RAIL TRAIL SEGMENT 7 – PHASE 2  
CITY PROJECT NO. c401413  
STATE PROJECT NO. ATPSB1L-5025(080)

7. **PLANS. REPLACE** plan sheets CP-2.01, DM-2.02, DM-2.04, EP-2.02, GP-2.02, GP-2.04, PP-2.01, PP-2.02, PP-2.04, PP-2.09, WP-1.02, and WP-1.04 with sheets CP-2.01, DM-2.02, DM-2.04, EP-2.02, GP-2.02, GP-2.04, PP-2.01, PP-2.02, PP-2.04, PP-2.09, WP-1.02, and WP-1.04 attached to this addendum.
8. **QUESTIONS SUBMITTED BY POTENTIAL BIDDERS.** Answers to questions submitted by potential bidders are attached to this addendum.

REVISIONS	
NO ADDENDUM #3	04/13/2022

REFERENCES	
DATE	1/28/22
SCALE	1" = 20'
DRAWN	J. MINKEL
DESIGN	C. PATCHIN
CHECKED	J. DEAN
FIELD BOOK:	
DRAWING #	EP-2.02
VAULT NO.	7079B

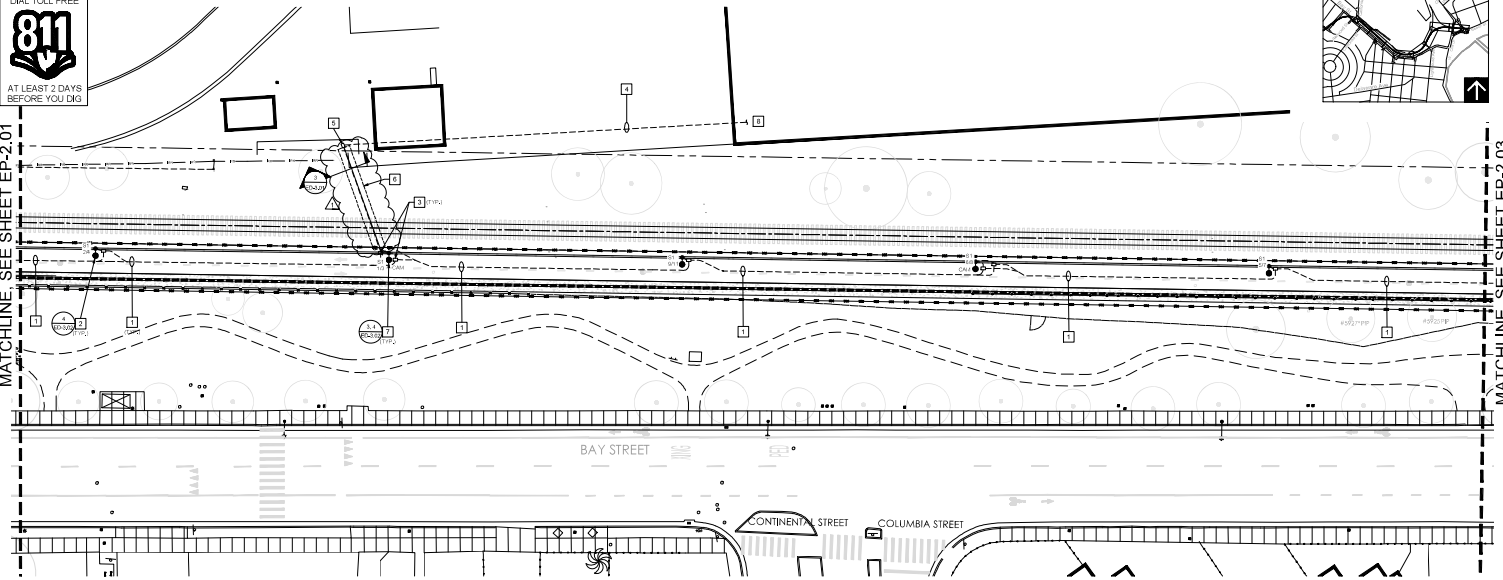
1. PROVIDE NEW UNDERGROUND DUCTBANK WITH (3) 2" CONDUITS FOR LIGHTING CIRCUITS AND (3) 2" CONDUITS FOR FIBER OPTIC CABLES. SEE SINGLE LINE DIAGRAM FOR CONDUCTOR SIZE. (SHEET EP-1.02) AND CAMERA DIAGRAM FOR FIBER OPTIC CABLE REQUIREMENTS (SHEET EP-3.02).

2. PROVIDE TYPICAL POST LIGHT. REFER TO SHEET EP-3.02, DETAIL 4 FOR POST BASE DETAIL.
3. NOT FLUSH IN GRADE PULL BOXES (MIN. 18" DEEP). PROVIDE ONE PER POLE FOR LIGHTING. PROVIDE ONE EVERY OTHER POLE AS SHOWN FOR FIBER OPTIC CABLES. LABEL LIGHTING COVER "ELECTRICAL" AND FIBER OPTIC COVER "COMMUNICATIONS".

7. PROVIDE TYPICAL POST LIGHT WITH CAMERA BOX AND TVD CAMERAS. SEE SHEET EP-3.02, DETAIL 3.
8. TRANSITION TO INDOOR RATED CABLE WITHIN THE FIRST 60' OF ENTERING THE ADMINISTRATION BUILDING AS PER CODE (IF REQUIRED).

REFERENCES	DATE	SCALE
FIELD BOOK	1/28/22	AS SHOWN
DRAWING #	GP-2.02	
GP-2.01-RC15		
CHECKED	DC	70798

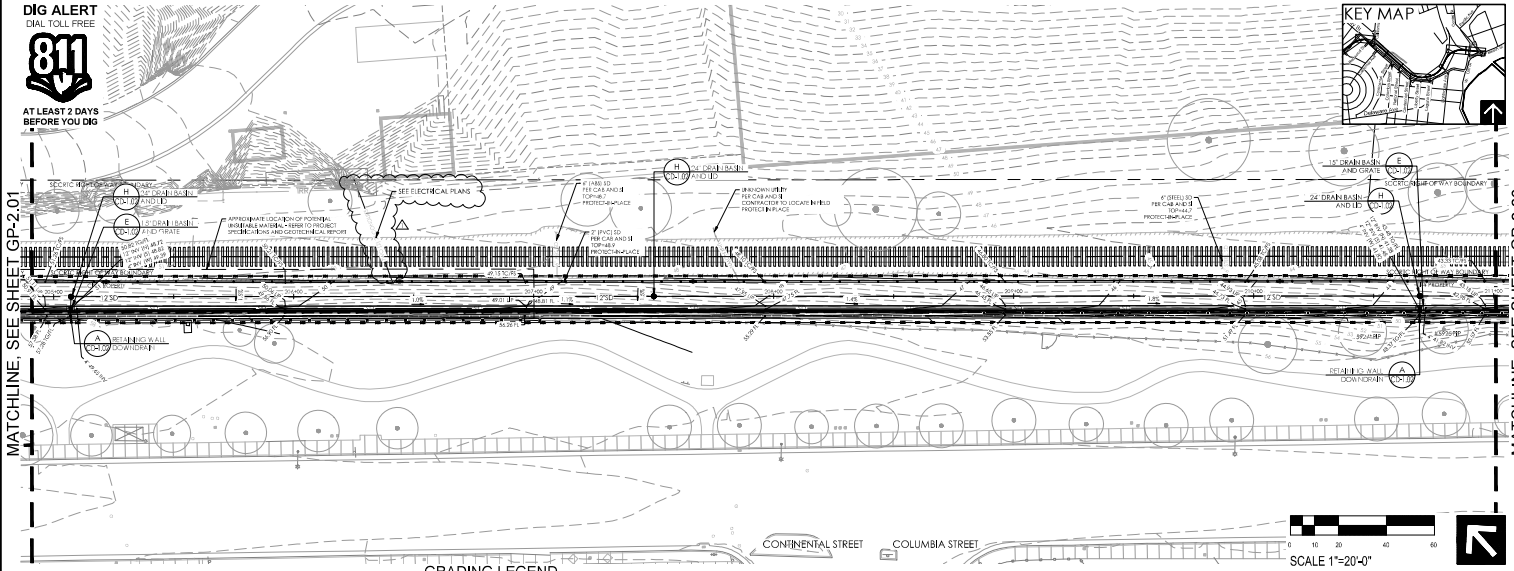
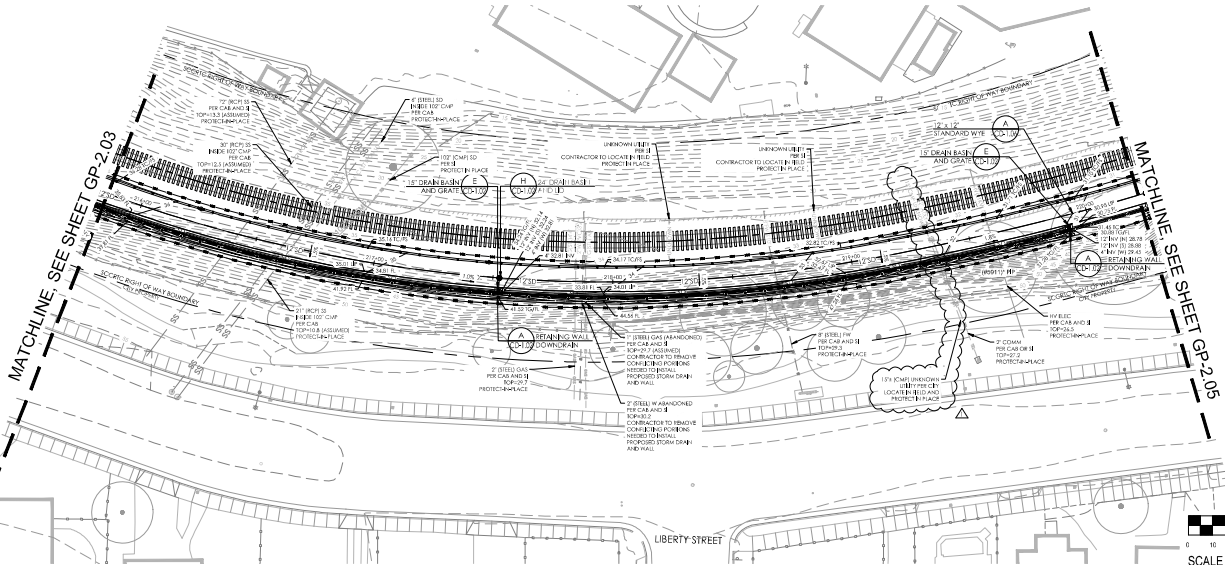
REVISIONS		
1	ADD: DRAINAGE	04/13/2022
